[Revisions to documents]

R20TS0241EJ0100

Renesas Starter Kit+ for RX65N-2MB

User's Manual Rev.1.00, Circuit Diagram Rev.1.00

Figure 2. Corrections to SW4.4 in Circuit Diagram

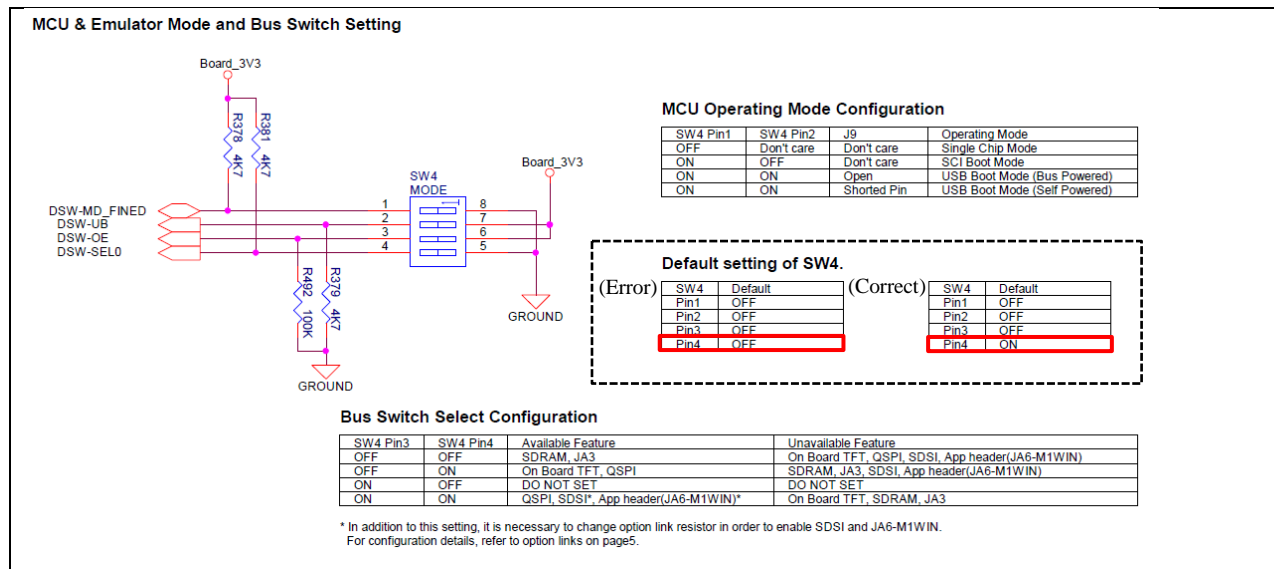
There was an error in the shipment status of the DIP switch SW4.4 (pin 4 of SW4) on the CPU board.

Error: SW4.4:OFF

Correct: SW4.4:ON

The default setting of Pin4 of SW4 in "MCU & Emulator Mode and Bus Switch Setting" in page 8 is to be revised as shown in Figure 2. The part to be revised is framed in red.
